[Docket No. 94-SW-27-AD; Amendment 39-9276; AD 95-06-03]

Airworthiness Directives; Robinson Helicopter Company Model R22 Helicopters

95-06-03 Robinson Helicopter Company: Amendment 39-9276. Docket No. 94-SW-27-AD.

FIGURE 1

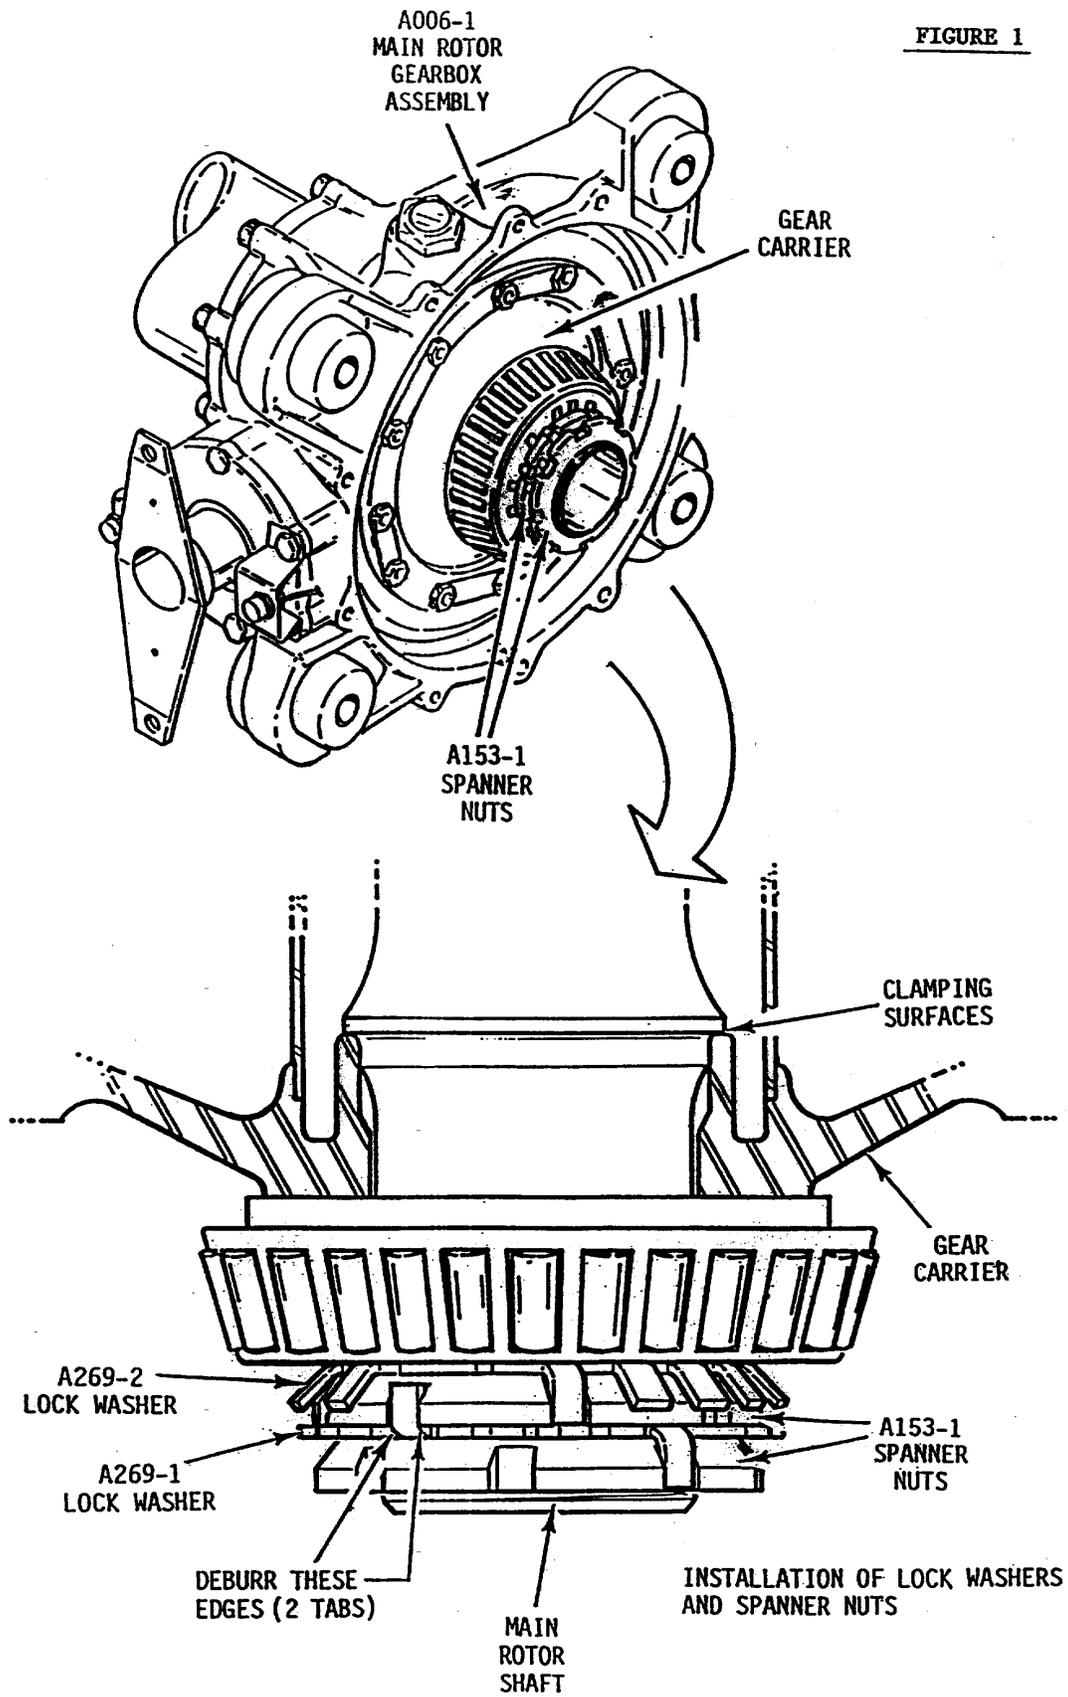
(viii) Before installing the lock washer, P/N A269-1, note that the edges are sharp on one side and rounded on the other. De-burr the sharp edges on two opposite tabs (see figure 1). This will reduce the chance of cracking when these tabs are bent up. Install the lock washer with the rounded edges toward the installed nut.

(ix) Apply anti-seize, P/N A257-9, to the chamfered-side face and threads of the lower nut. Align the two de-burred tabs with the upper nut and install the lower nut with the chamfered side against the lock washer. Hand-tighten the nut to hold the washer in place. Bend the two de-burred tabs up to lock with the upper nut. Torque the lower nut to between 90 and 120 ft.-lb., as required to align the two additional tabs. Do not untorque the nut to align the lock washer tabs with the nut. For the two tabs that are aligned with the recessed areas, bend down the tabs into the recessed areas of the nut to lock the lower nut.
